SUBSURFACE WASTEWATER DISPOSAL SYSTEM APPLICATION

PROPERTY LOCATION		>> CAUTION: PERMIT REQUIRED - ATTACH IN SPACE BELOW <<	
City, Town, or Plantation	PORTLAND	PORTLAND	PERMIT # 10004 TOWN COPY
Street or Road	CLIFF ISLAND	Date Permit Issued: 8/31/06	\$ 1,000.00 <input type="checkbox"/> Double Fee Charged
Subdivision, Lot #		<i>Jeannie Bourke</i> Local Plumbing Inspector Signature	L.P.I. # 0732
OWNER/APPLICANT INFORMATION			
Name (last, first, MI)	NEWIRTH, JAYNE <input checked="" type="checkbox"/> Owner <input type="checkbox"/> Applicant		
Mailing Address of Owner/Applicant	23 WINDPATH EAST WEST SPRINGFIELD, MA 01089	<i>20066013</i>	
Daytime Tel. #		109 BF 29	Municipal Tax Map # _____ Lot # _____
OWNER OR APPLICANT STATEMENT		CAUTION: INSPECTION REQUIRED	
I state and acknowledge that the information submitted is correct to the best of my knowledge and understand that any falsification is reason for the Department and/or Local Plumbing Inspector to deny a Permit.		I have inspected the installation authorized above and found it to be in compliance with the Subsurface Wastewater Disposal Rules Application.

REPLACEMENT SYSTEM VARIANCE REQUEST

RE: NEWITH - CLIFF ISLAND

JANE NEWITH
CLIFF ISLAND

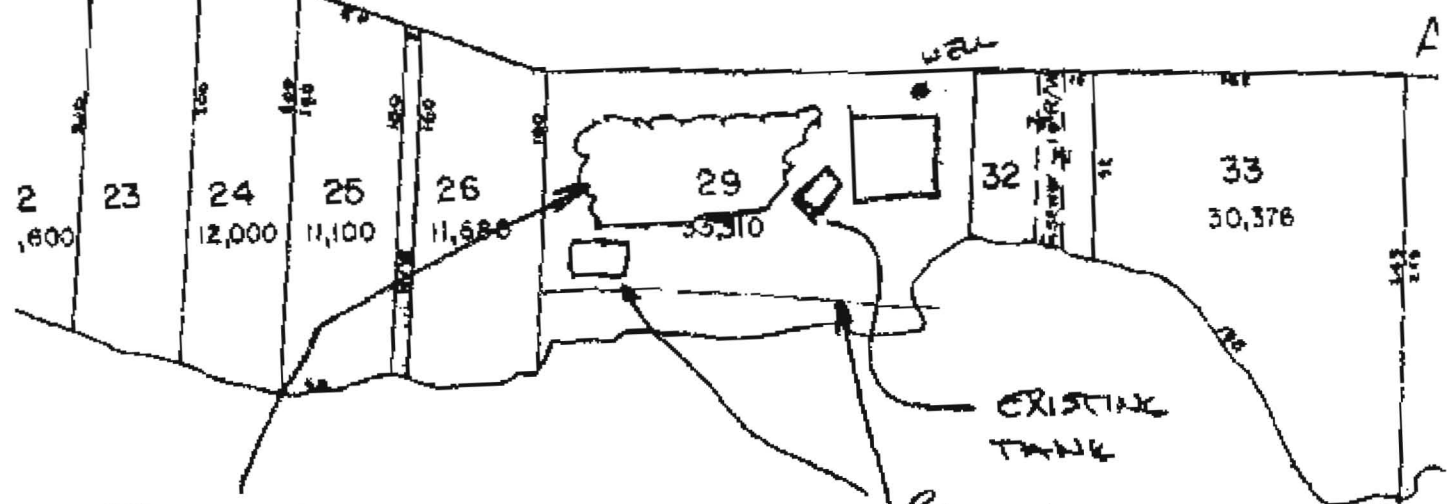
ATTACHED IS JANE-NEWITH LOT WITH LEDGE OUTCROP DEMONSTRATED - THIS IS LEDGE AT OR NEAR THE SURFACE I 6" SIK DEPTH. THERE IS A SMALL TERRACE WHERE I HAVE DESIGNED THE SYSTEM THAT HAS THE ONLY SIGNIFICANT AMOUNT OF SOIL ON THE LOT.

EDGE OF
LEDGE OUTCROP
TOP OF LEDGE
ABOUT 600 TO
6" DEPTH SURFACE

CAN'T GET SET BACK,
... A 29' VARIANCE

6" in depth of ledge
